**ELECTRONIC APPLICATION OF EAST )  
KENTUCKY POWER COOPERATIVE, INC. )  
FOR A CERTIFICATE OF PUBLIC )  
CONVENIENCE AND NECESSITY FOR )  
THE CONSTRUCTION OF A 161 kV )  
TRANSMISSION LINE IN PULASKI )  
COUNTY, KENTUCKY AND OTHER )  
GENERALRELIEF )**

**CASE NO.  
2025-00311**

**RESPONSES TO STAFF’S THIRD INFORMATION REQUEST**

# **EKPC Cooper - Alcalde Greenfield Transmission Line Routing Study**

Figure 49: Route B

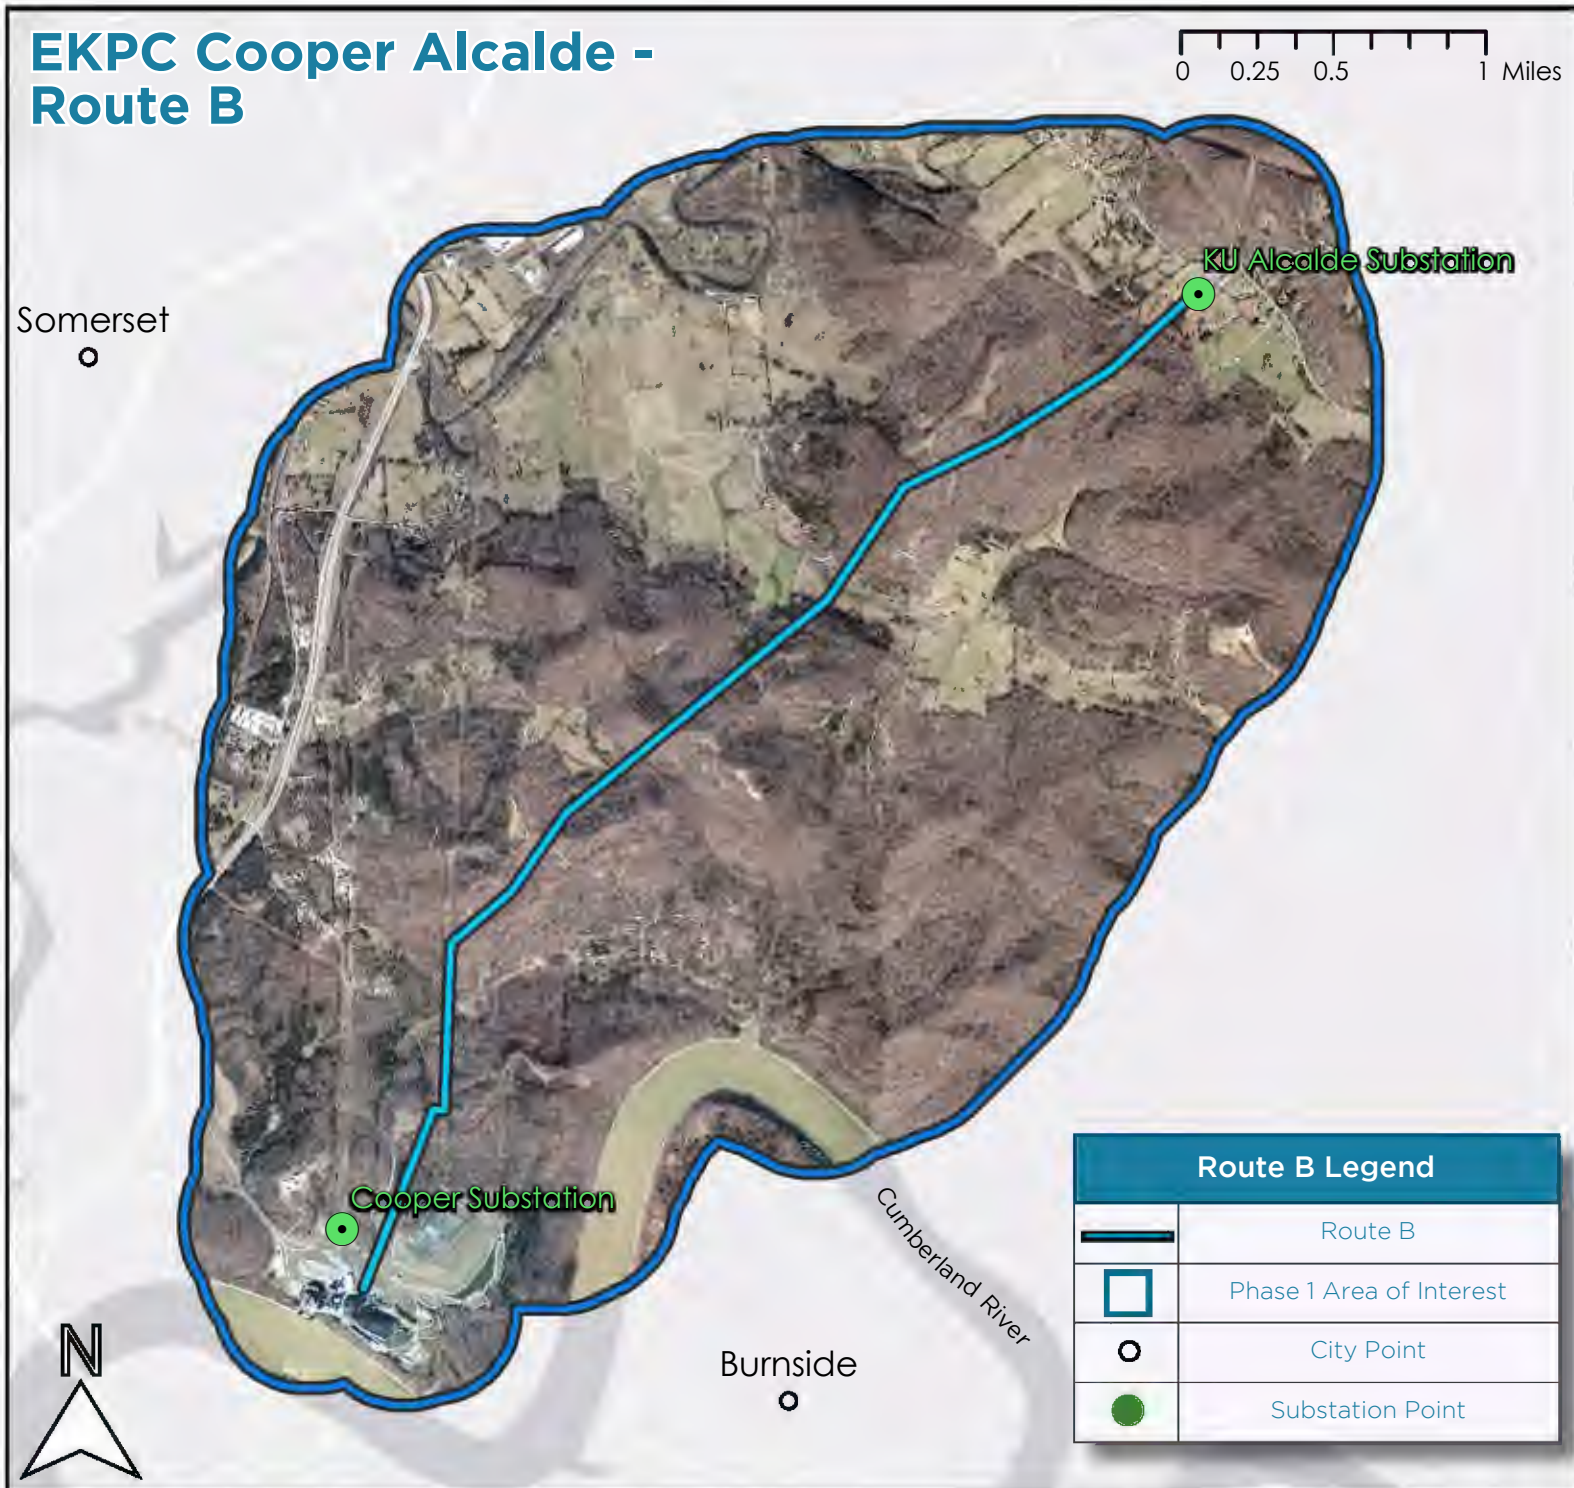
**Request 1.**                Refer to EKPC’s response to Commission Staff’s Second Request for Information, Item 7 and Item 8. See also the Direct Testimony of Lucas Spencer Attachments EKPC Cooper Alcalde – 161kV Greenfield Transmission Routing Study, Part XI: Alternate Routes at 63.

a.            Confirm that the proposed project entails the installation of a double circuit line the entire length of the proposed line route.

b.            If confirmed, then reconcile the statement from the routing study, “The first 2.90 miles of Route B is a double circuit transmission circuit, while the final 1.64 miles of Route B is a single transmission circuit.”<sup>1</sup>

c.            If not confirmed, submit an updated Siting Study or explain why an updated Siting Study is unavailable.

b. During the routing study for the 161kV Cooper-Alcalde double-circuit transmission line, multiple route alternatives were evaluated in accordance with the EPRI-Kentucky transmission line routing methodology. Route B was selected as the preferred route based on that evaluation and was correctly identified as the best-performing alternative, this is outlined further in the corrected siting study, Attachment LS-1, Appendix A, which is attached to this response as Attachment 3-1(b).

An inconsistency has been identified in the report and testimony where the line length of 5.25 miles, which is the line length for Route C in the siting study, was inadvertently included in various areas of testimony and the application. Route B is described in the siting study as approximately 4.54 miles. This was a clerical error that unfortunately was carried forward into various places in the case record. The 5.25-mile line length is the incorrect line length for the Cooper-Alcalde project and the 5.25-mile line length does not represent the selected Route B. EKPC is providing red-lined versions of the various documents where the clerical error was made regarding the 5.25-mile length to reflect the correct 4.54 mile length as described for Route B on the siting study.

As the project advanced from the routing study to engineering design, detailed survey data in the form of LiDAR was acquired for the purposes of design. It is standard industry practice at this stage to make modest adjustments to the conceptual centerline to account for real-world terrain, constructability considerations, and input received during the public open house process. The final centerline adjustments reflect sound engineering judgement during the design process. The resulting final centerline has a designed length of approximately 4.95 miles. This alignment is shown on Attachment LS-3 to the Direct Testimony of Lucas Spencer that was filed with the

Application. Attachment LS-3 represents the engineering design with final line length in station format, with an ending station of approximately 261+50 ft, or 26,150 ft. This is seen in Attachment LS-3, page 4, which is approximately 4.95 miles. Attachment LS-3 is a more detailed design of the proposed transmission line and was developed later in the project than the siting study.

While the original routing study and testimony contained inconsistent mileage references due to the early oversight described above, the routing methodology, route selection, and final design have remained consistent throughout the project. The correct description, maps, and costs were reflected for Route B. The only incorrect information was the length of the line. The final design documents accurately reflect the proposed alignment and total length. The siting report has been updated to reflect the correct route descriptions; the application and testimony have been updated to reflect the final centerline length based on the design initially attached in Attachment LS-3.

When EKPC was developing the project and determining what landowners would need to be notified, EKPC used a corridor map. A corridor map contains a much wider area than just the parcels where the centerline crosses. Therefore, EKPC notified more landowners of the project than what was required, and all potentially impacted landowners were included. Overall, the routing study was performed with sound judgment and in conformance with industry accepted standards. Route B was appropriately selected and was scored as a double circuit transmission line for the full length of the line from EKPC Cooper-KU Alcalde and the final line length after design, as described above, is 4.95 miles.

c. EKPC has attached an updated siting report that reflects the correct route descriptions and updates some of the other information in the report to correctly reflect the scope of the routing study. Route B continues to be the best overall choice for the project.
